RIBA STAGE 4 TECHNICAL DESIGN

GAG257 - 4300E

DWG TITLE - NE & SE ELEVATIONS AS PROPOSED REV - E

Barn Conversion to Residential Use at Redstart Barn, Brookhampton, Shropshire

NORTH-EAST ELEVATION AS PROPOSED

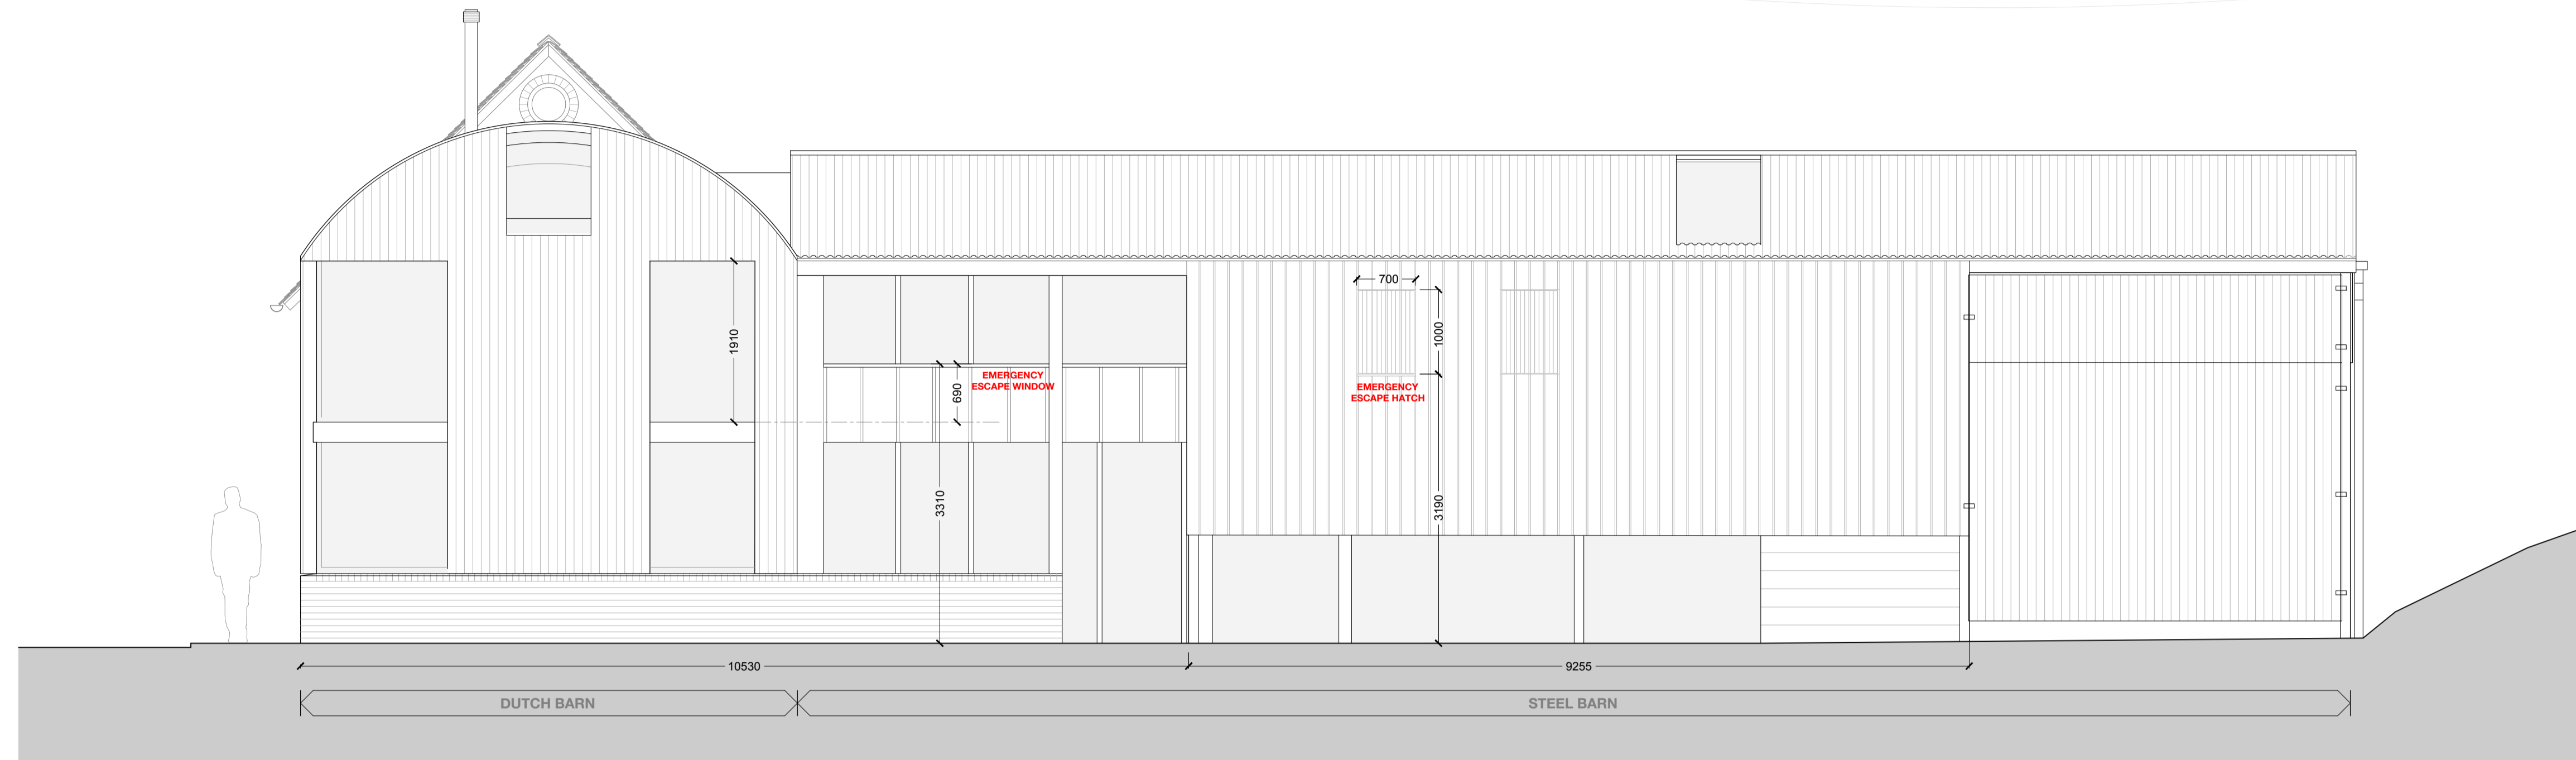
THE FOLLOWING DRAWINGS HAVE BEEN UPDATED TO INCORPORATE CLIENT REQUESTED CHANGES TO THE LAYOUT & DESIGN, PRINCIPALLY TO RAISE PROPOSED Gnd & 1st FLOOR LEVELS IN THE DUTCH BARN AND STEEL BARN :
